**ADMINISTRATIVE AMENDMENT**  
 File # 09AA-105A Project # 1000572  
 Addition of single-family, detached product. Delete 36 condo units and replace with 24 single-family units.  
 Russell B. Bingham 26 June '09  
 APPROVED BY DATE

**AMENDED SITE DEVELOPMENT PLAN FOR PRD THE PRESIDIO**

PROJECT # 1000572

**THE PRESIDIO UNIT 1,  
REPLAT OF TRACT J  
CENTEX HOMES**

ENLARGED SITE PLAN FOR SINGLE-DETACHED UNITS  
1"=30'

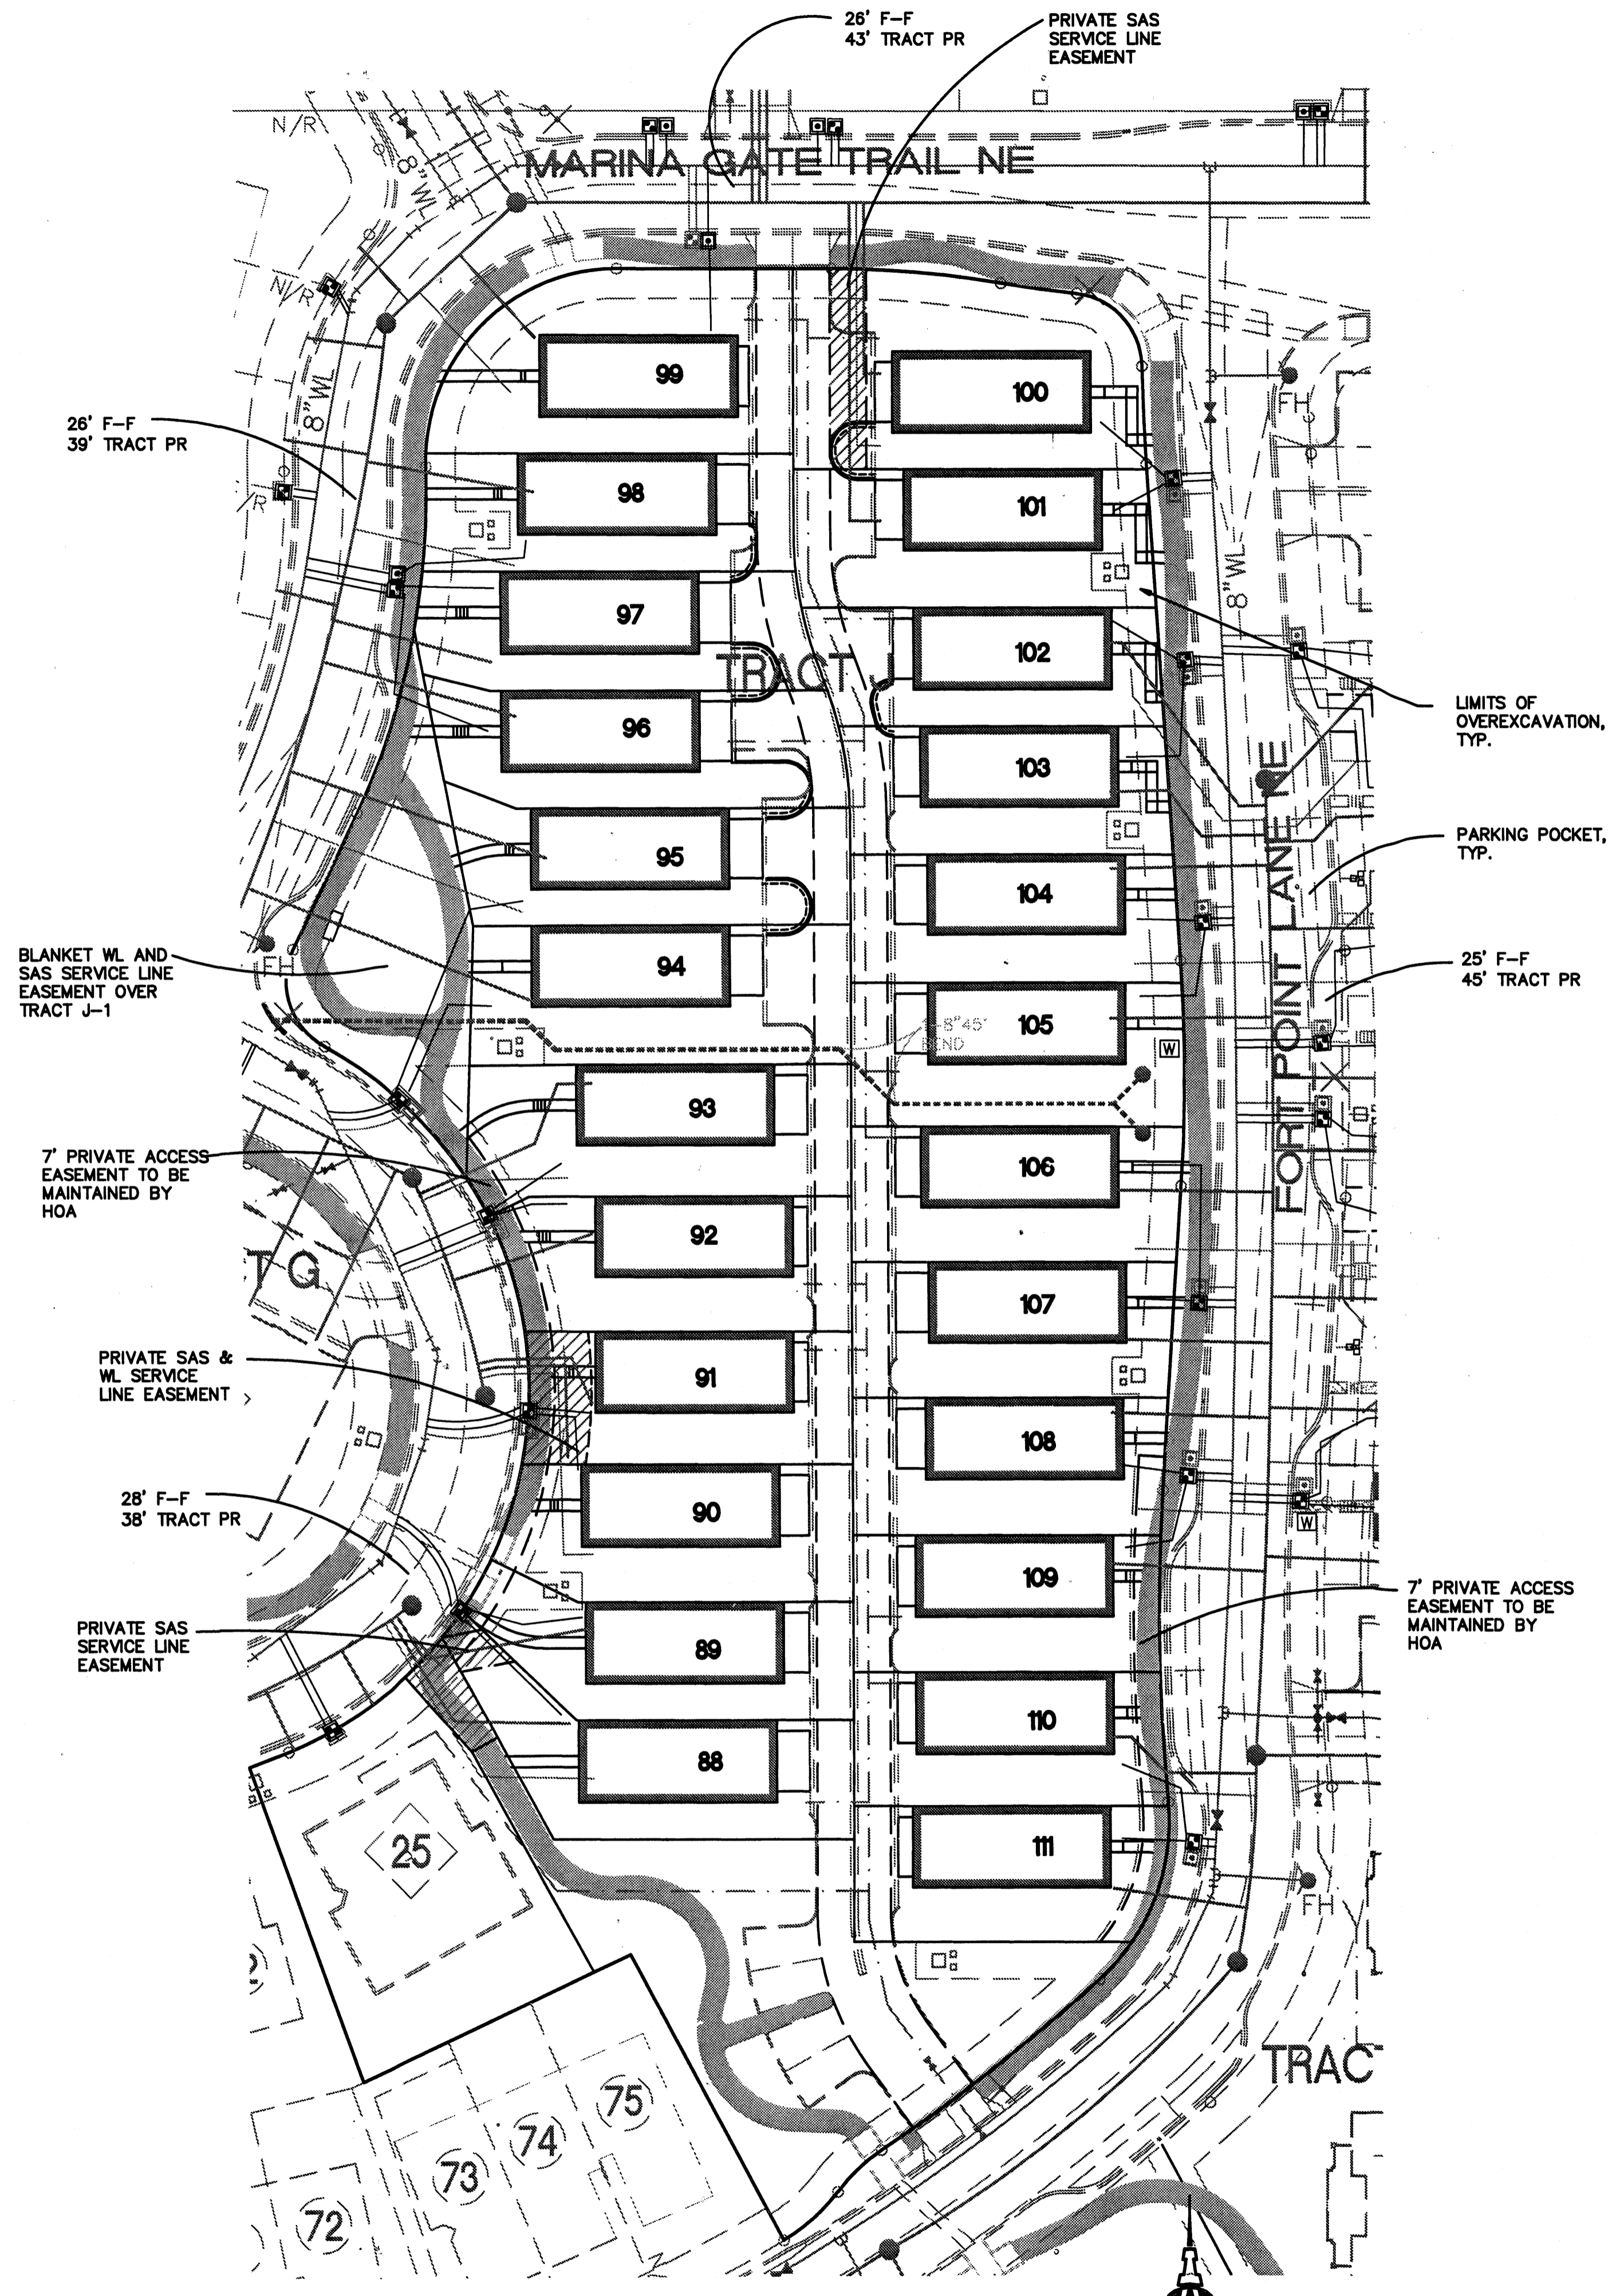
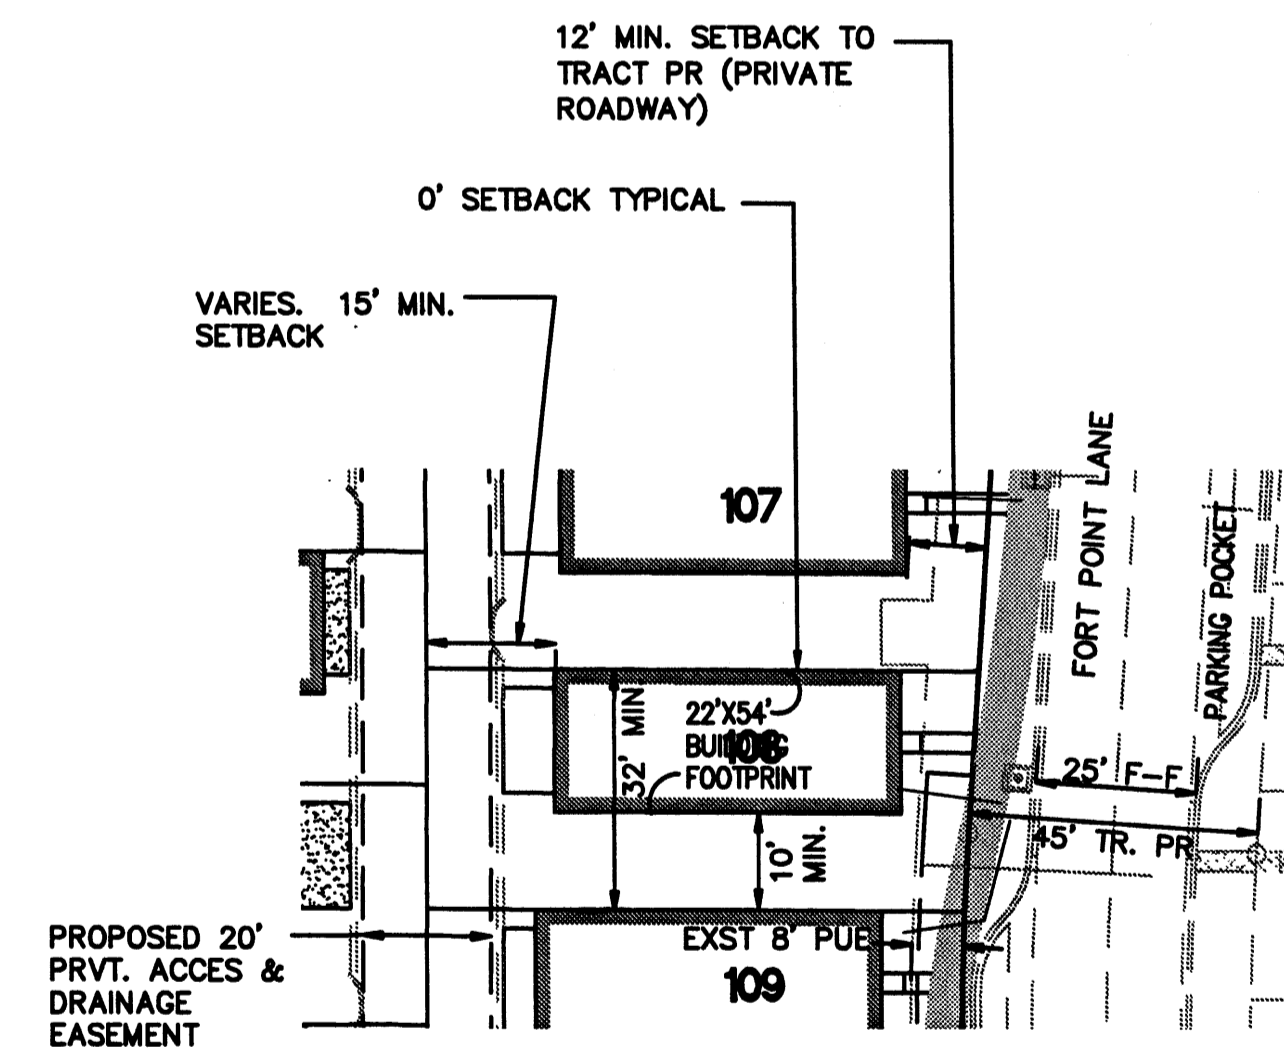
12 TRIPLEX CONDOMINIUM BUILDINGS (36 UNITS) SHALL BE REPLACED WITH 24 SINGLE DETACHED LOTS IN A SERIES OF REPLATS.

**GRADING & DRAINAGE:**  
DRAINAGE PATTERNS SHALL FOLLOW THE APPROVED PLAN FOR THE CONDOMINIUM UNITS, AND THE EXISTING CONDOMINIUM PADS SHALL BE RESHAPED TO ACCOMMODATE THE SINGLE-DETACHED LOTS. A PRIVATE DRAINAGE EASEMENT SHALL BE PROVIDED FOR AN 8" DRAIN LINE THAT IS INSTALLED.

**UTILITIES:**  
WATER & SAS MAINS AND SERVICES ARE EXISTING AND SHALL BE USED FOR THE NEW LOTS. ANY SERVICES NOT USED SHALL BE ABANDONED. PRIVATE FIRE LINE INTENDED FOR CONDOMINIUMS SHALL BE ABANDONED.

GRADING PLAN FOR 8 SINGLE-DETACHED UNITS  
1"=20'

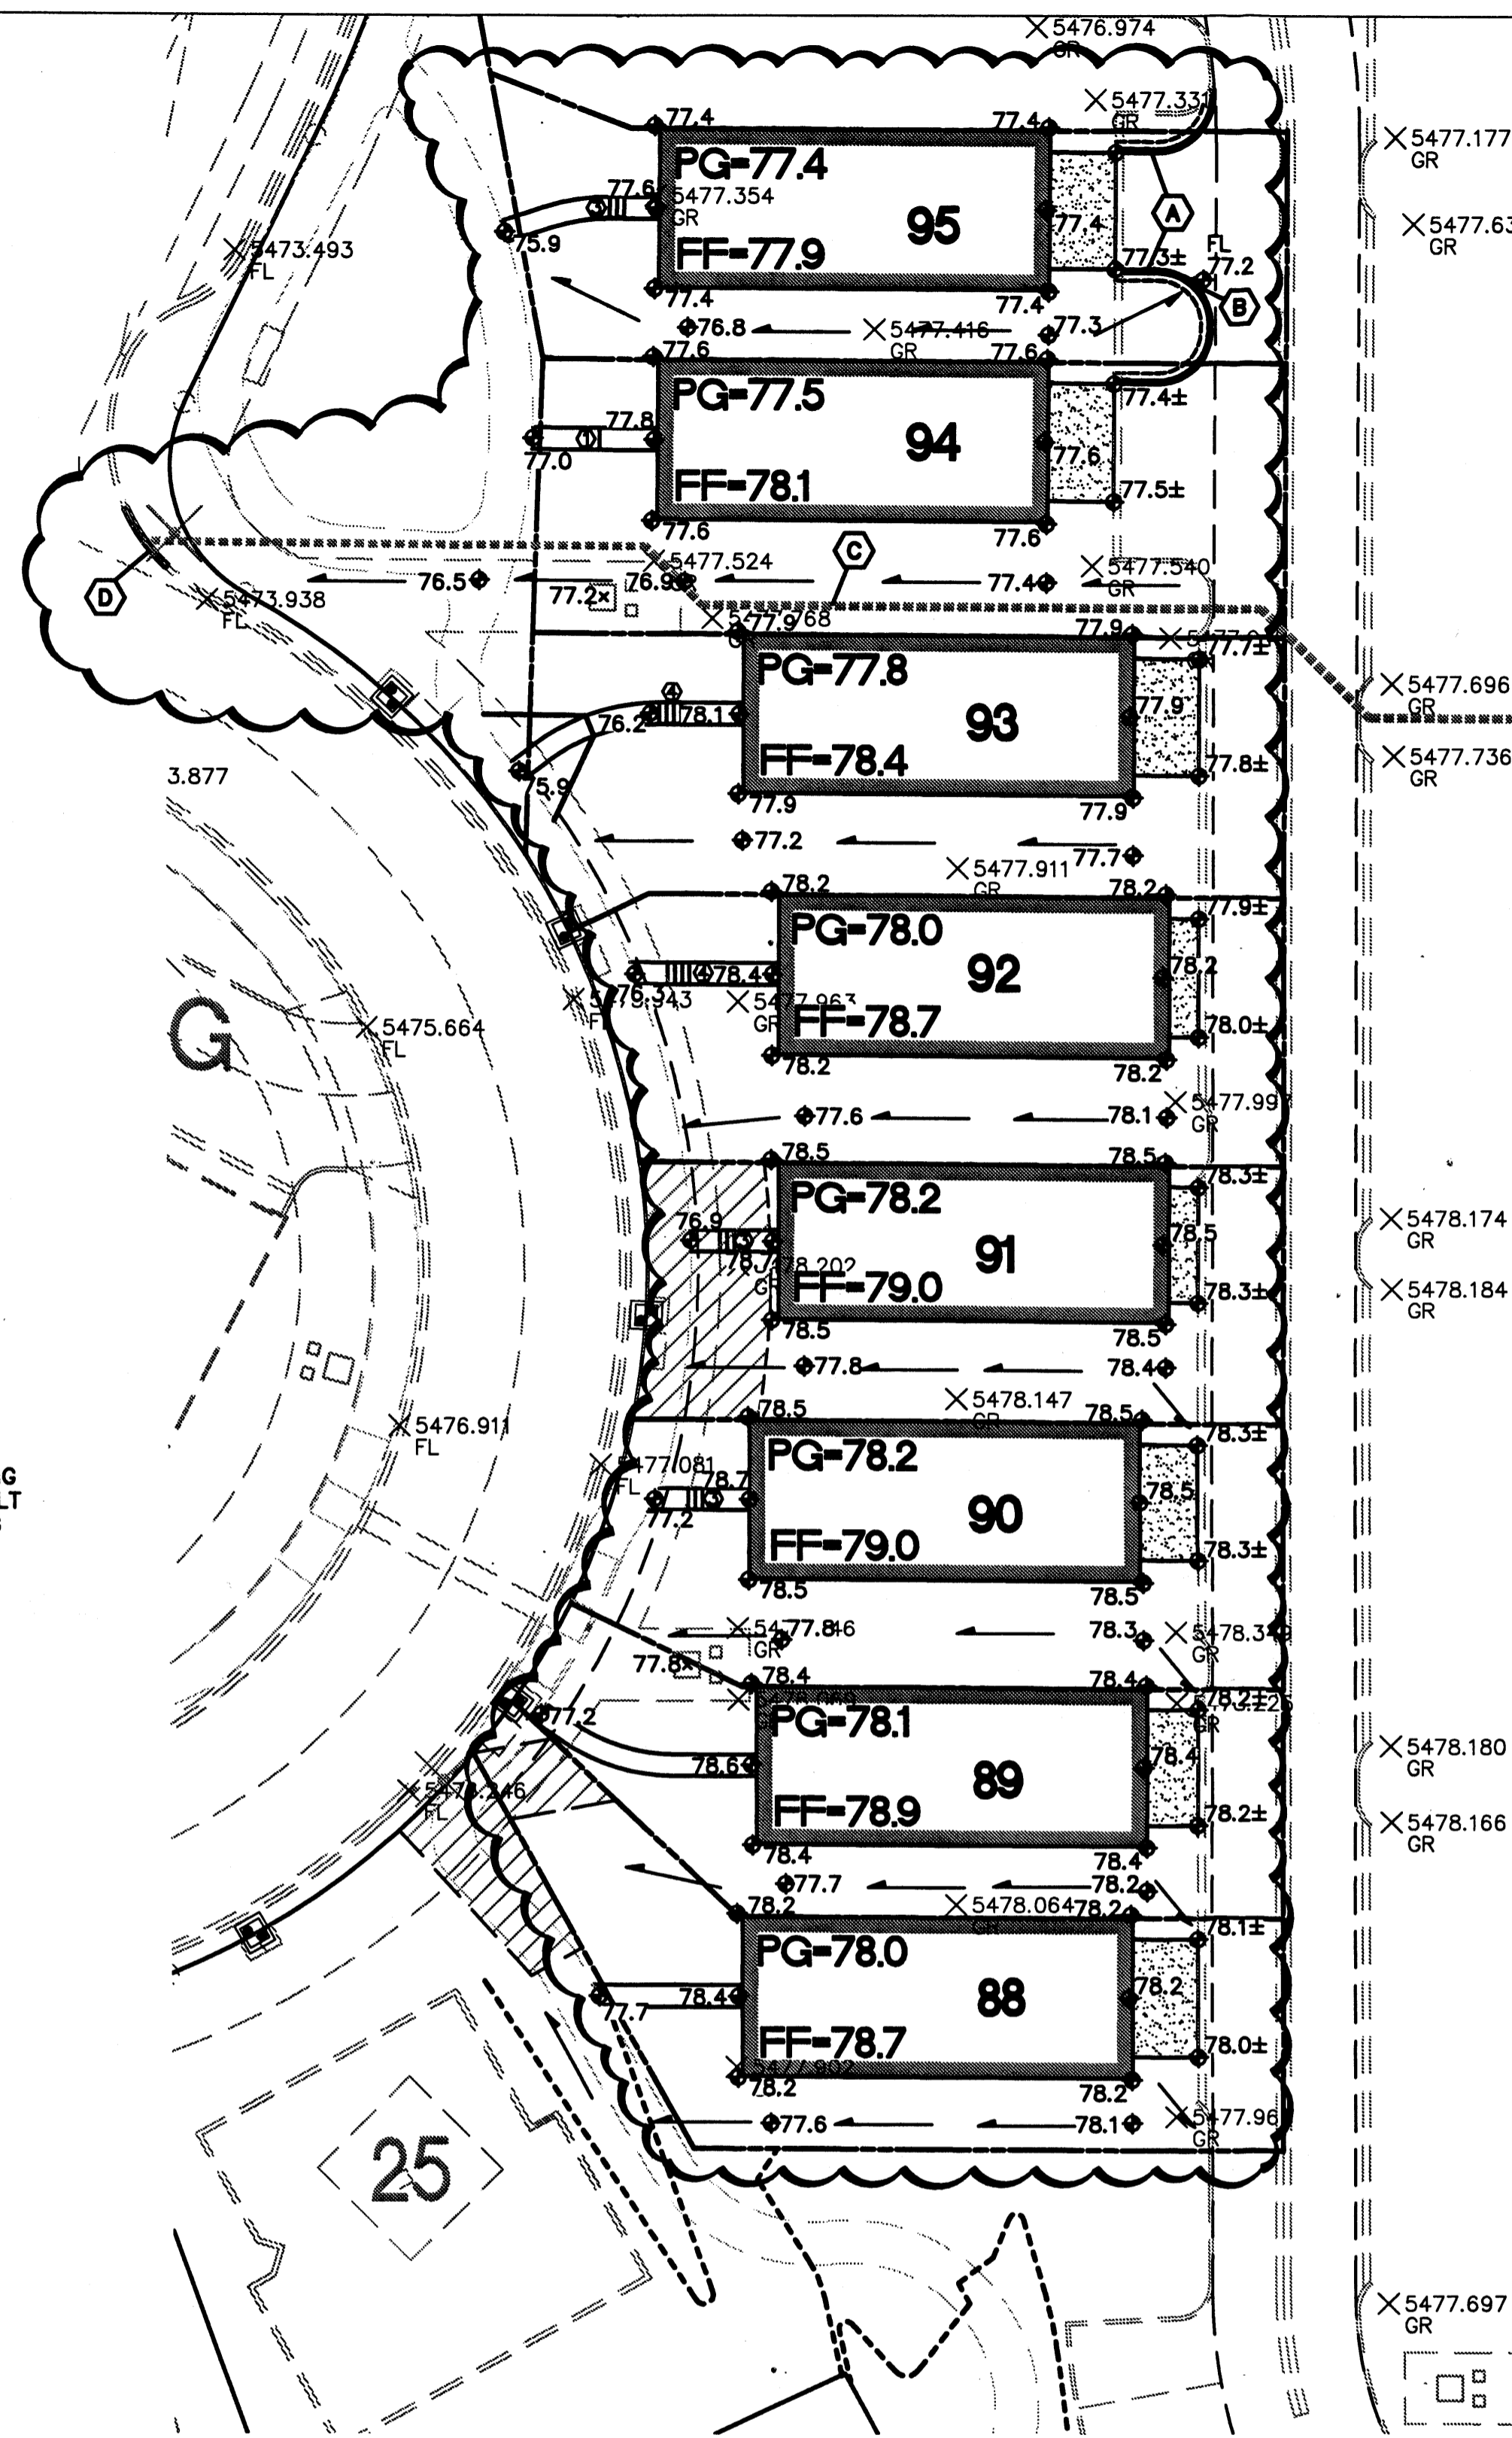
THIS GRADING PLAN SHOWS REVISED GRADES FOR THE AREA WHERE THE FIRST OF THREE GROUPINGS OF 8 SINGLE-DETACHED UNITS WILL REPLACE THE PREVIOUSLY PROPOSED TRIPLEX CONDOS (12 TOTAL UNITS).

DRAINAGE PATTERNS SHALL FOLLOW THE APPROVED PLAN FOR THE CONDOMINIUM UNITS, AND THE EXISTING CONDOMINIUM PADS SHALL BE RESHAPED TO ACCOMMODATE THE SINGLE-DETACHED LOTS.
